A G E N D A

Architectural Review Board

April 23, 2019

100/102 South Capitol Parkway

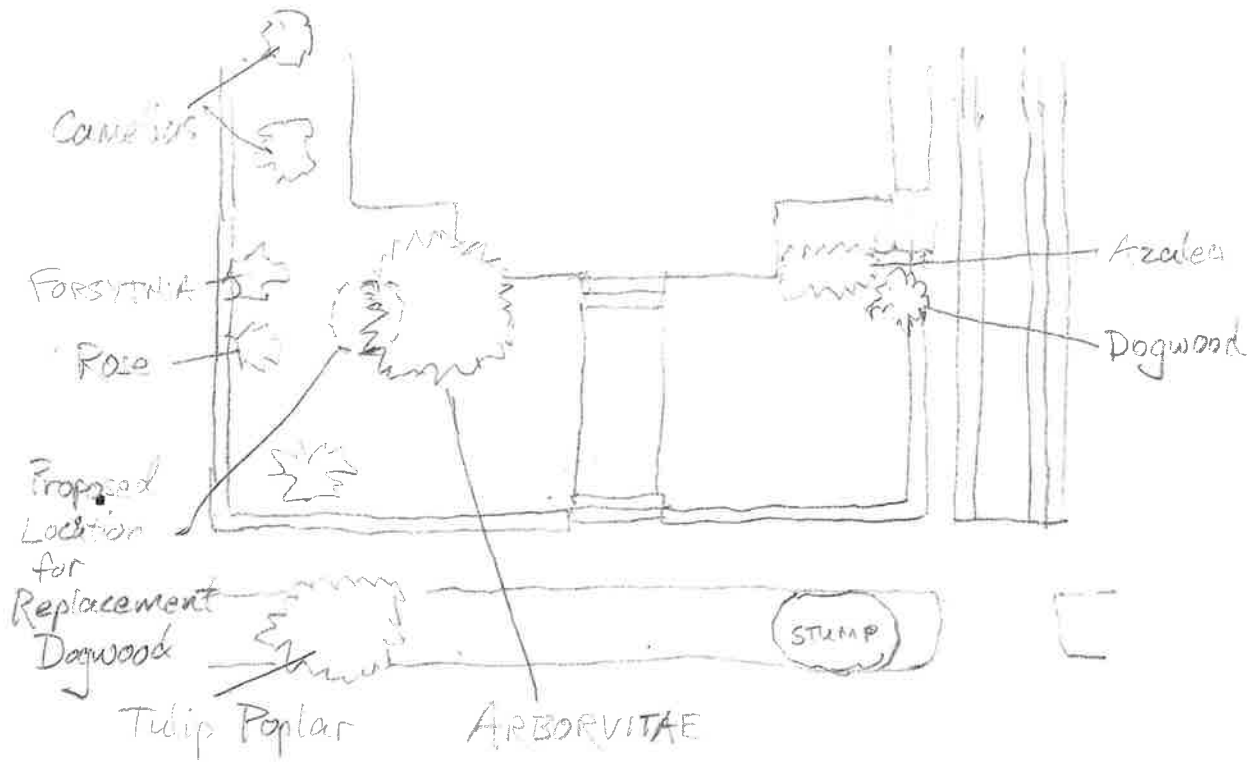
- This is an ornamental tree. It’s possible to prune it away from the building.
- The ARB approved after the fact a similarly situation arborvitae from the porch corner at 447 S Goldthwaite Street.

4 South Capitol Parkway

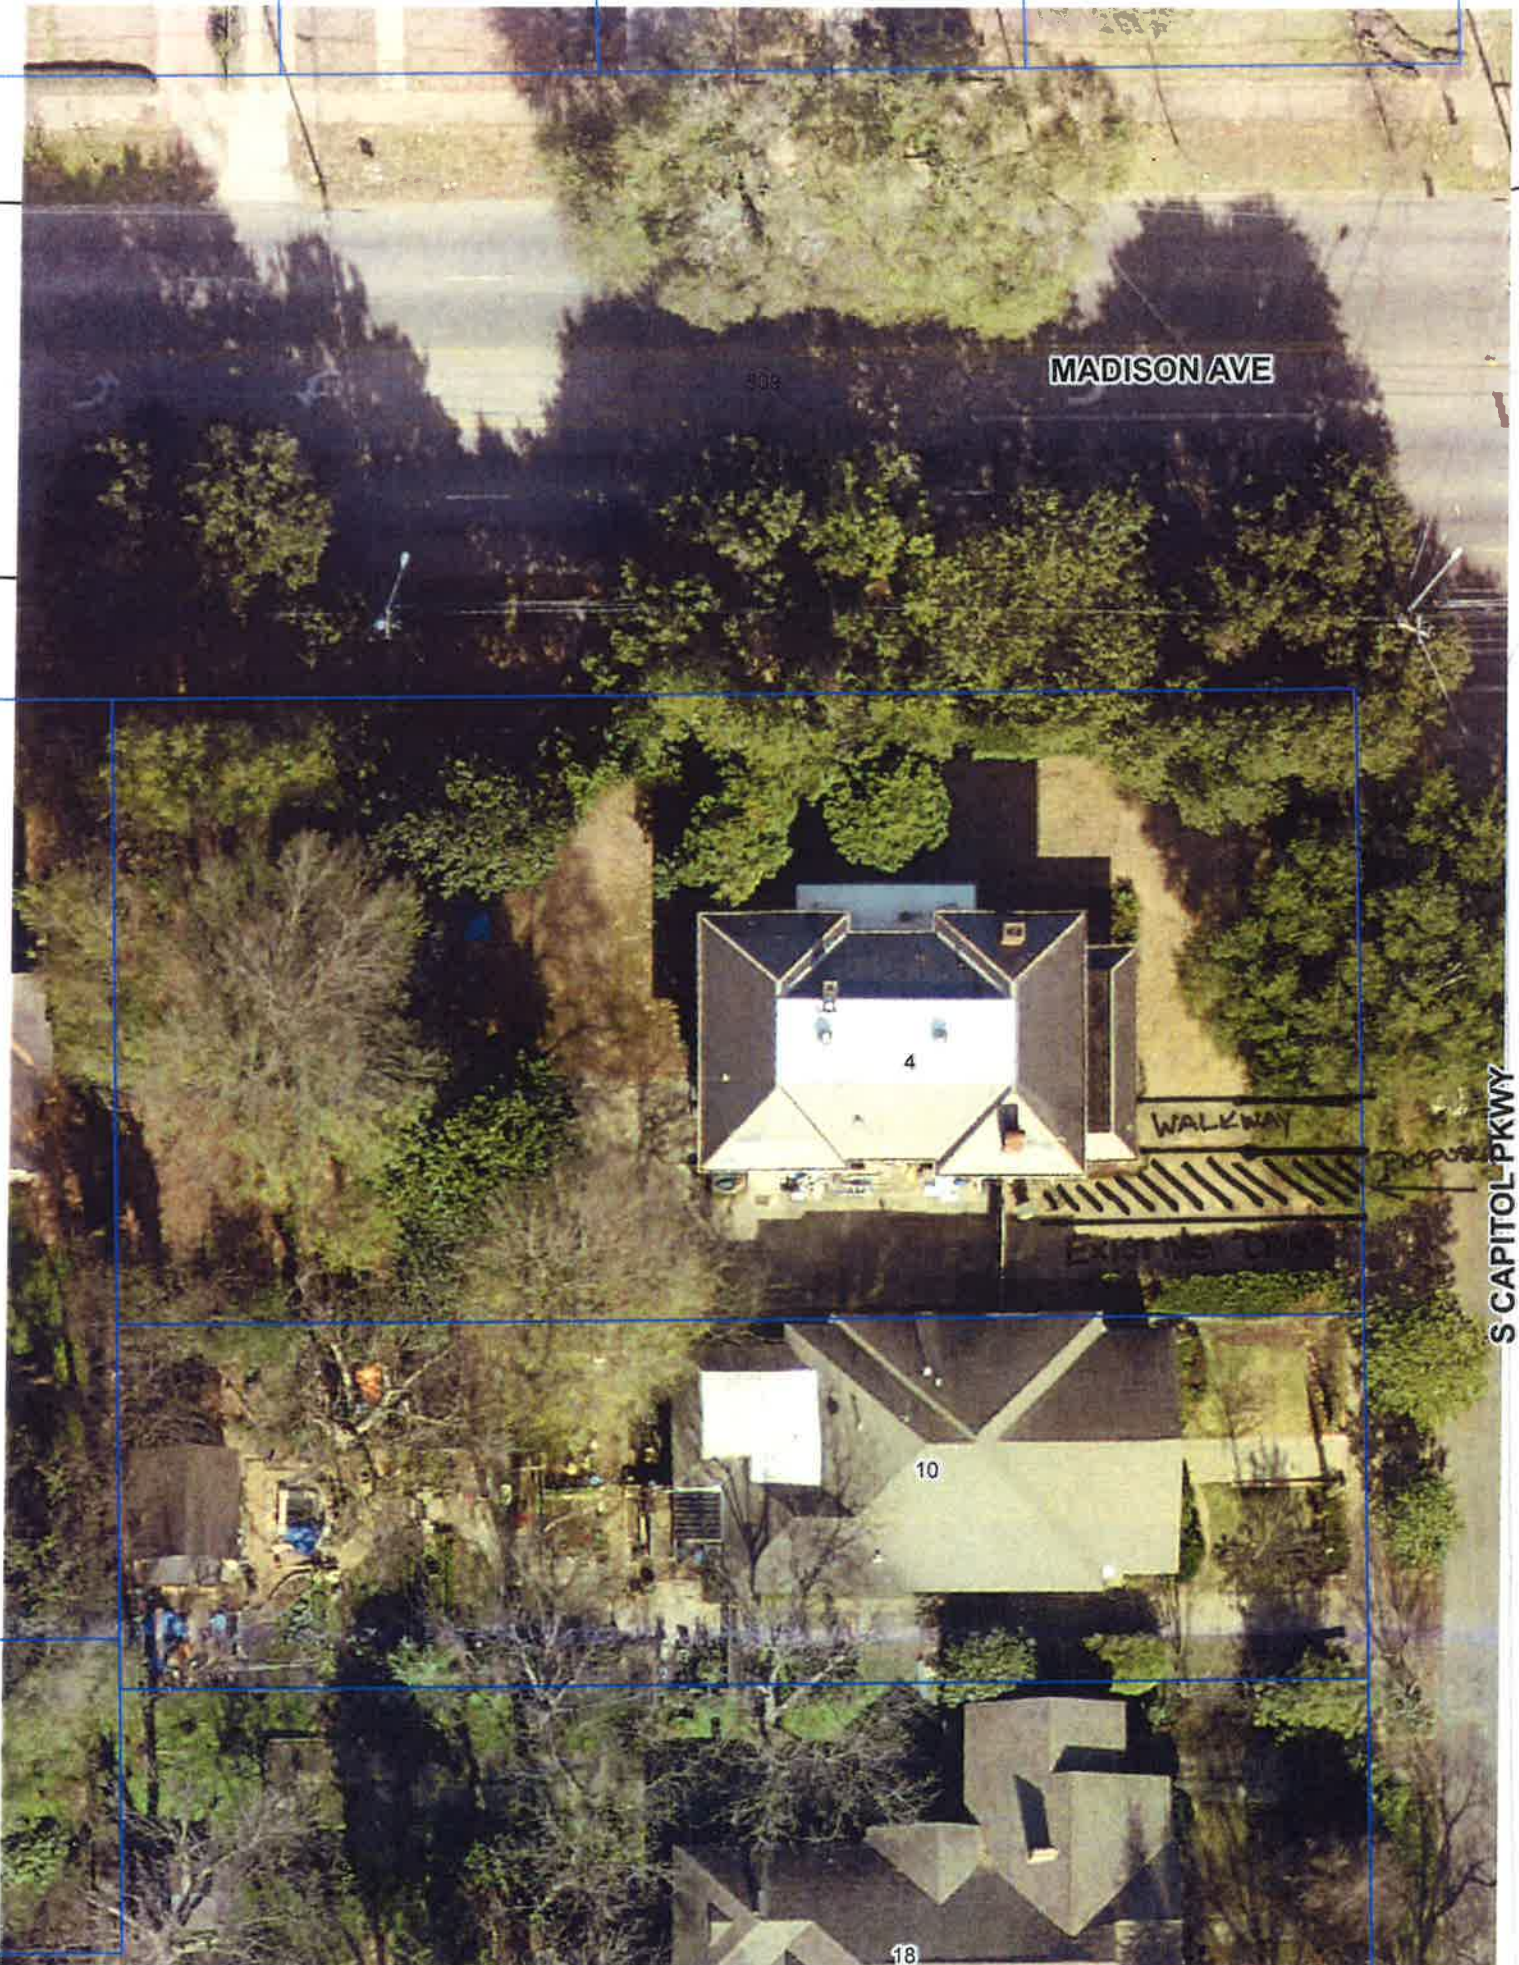
- The house is situated on a double lot (100' wide) and on the corner of Madison Avenue which limits on street parking. People driving west on Madison who turn onto the Parkway tend to turn very wide and run into trees and parked vehicles with some regularity.
- The petitioner discussed with staff making the delineation between the pedestrian walkway and vehicular area so that someone down the line would have more difficulty turning the front walk into part of the parking area.

514 Cloverdale Road

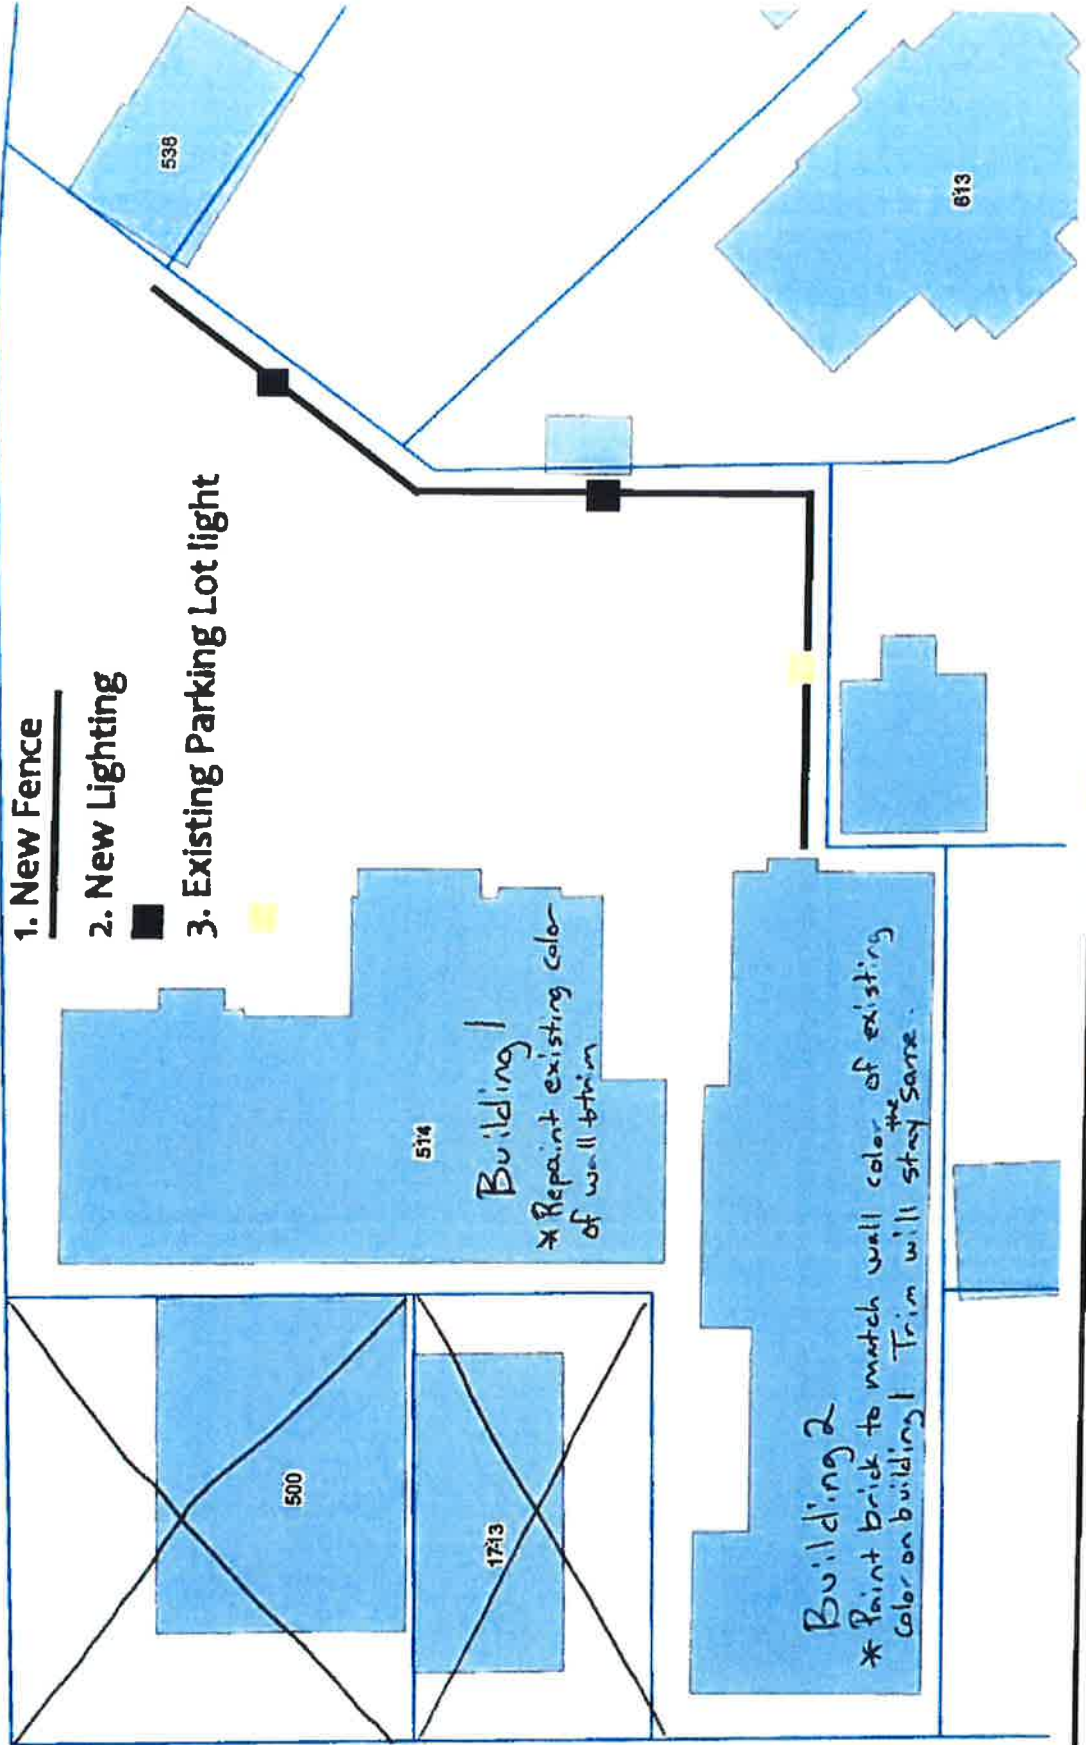
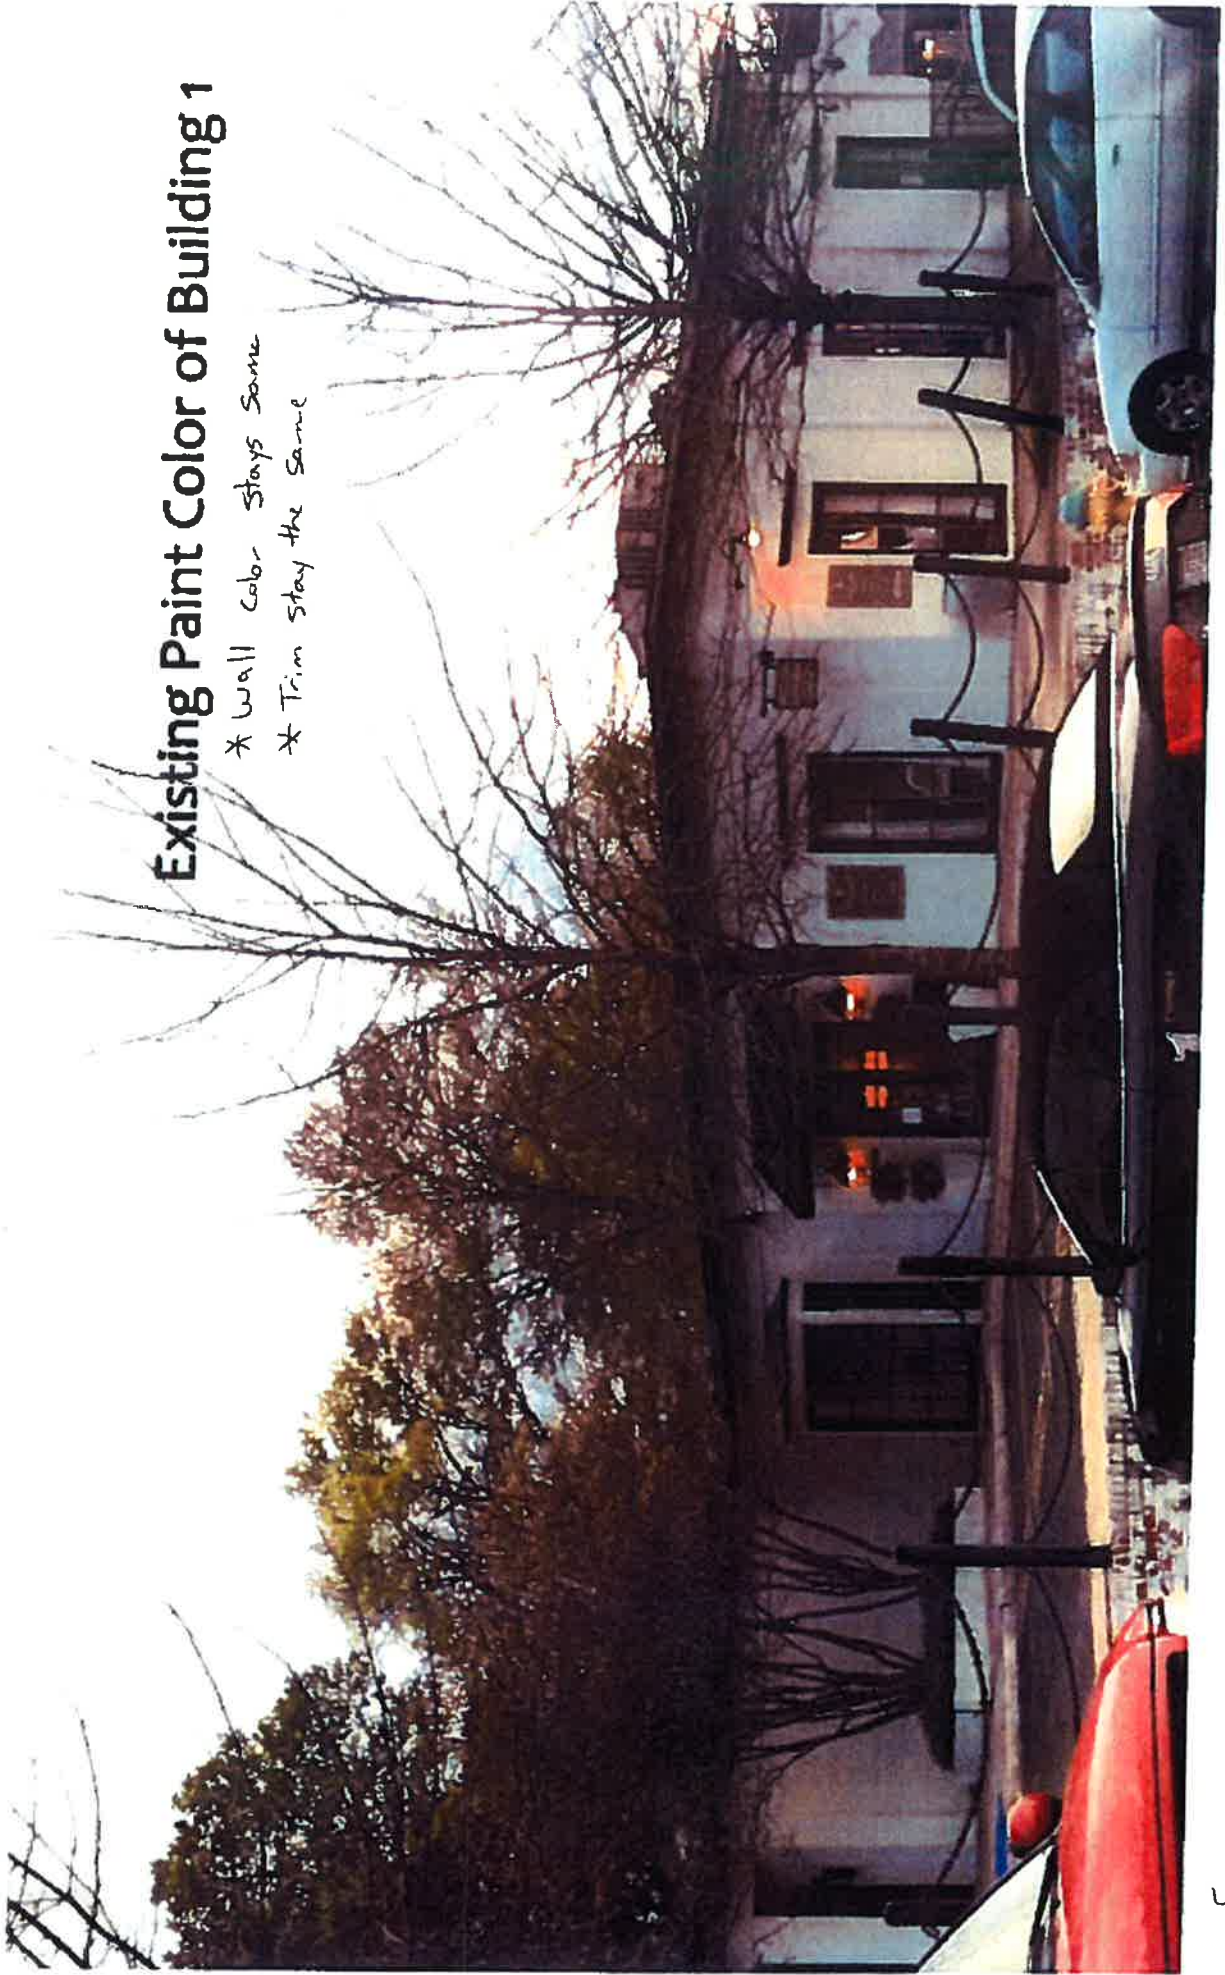
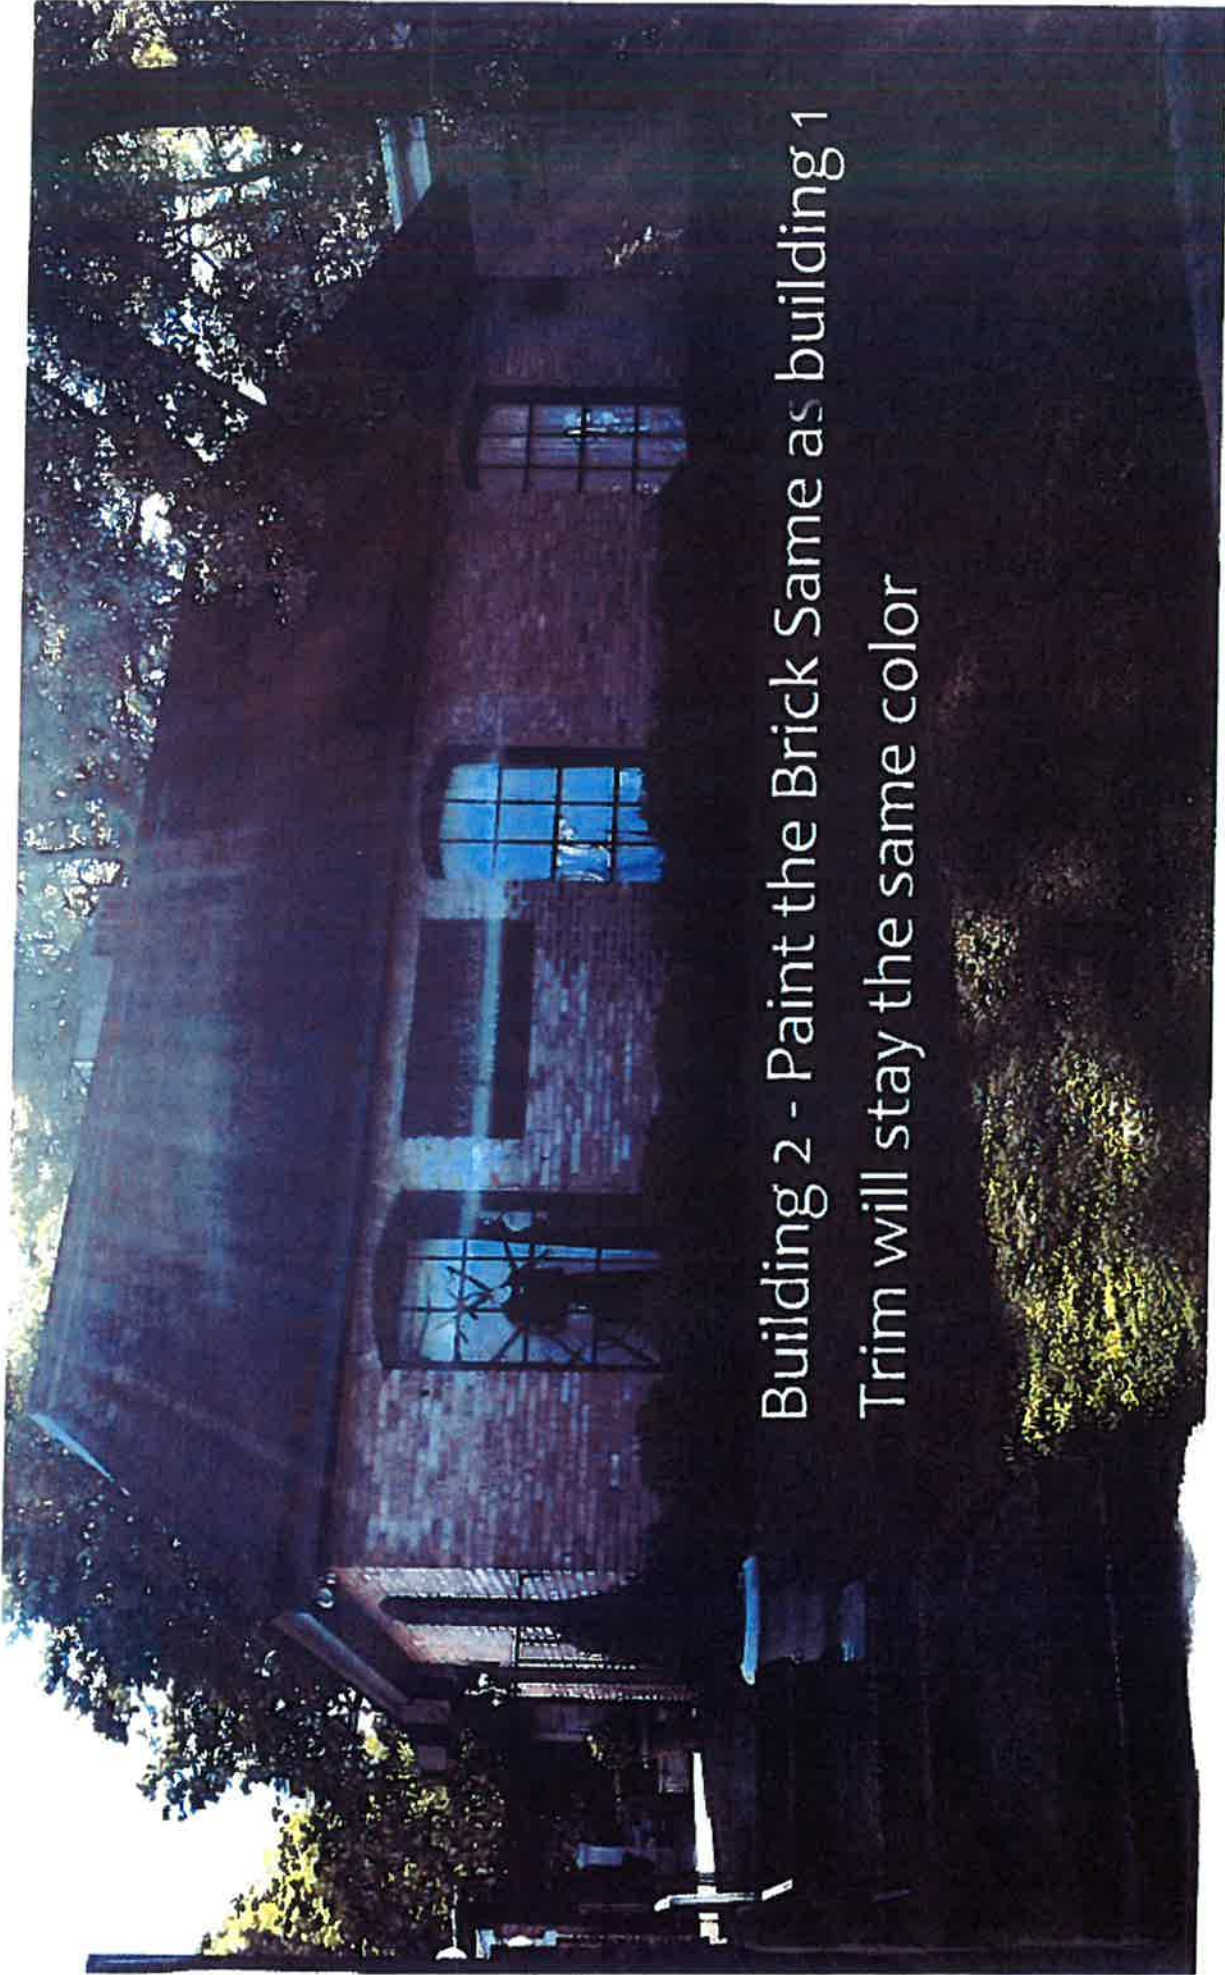
- One of the concerns with painting unpainted brick is that the paint can seal moisture into older, soft brick and mortar. That is not an issue with a 1977 building, and the building is not old enough to be a contributing historic building quite yet.
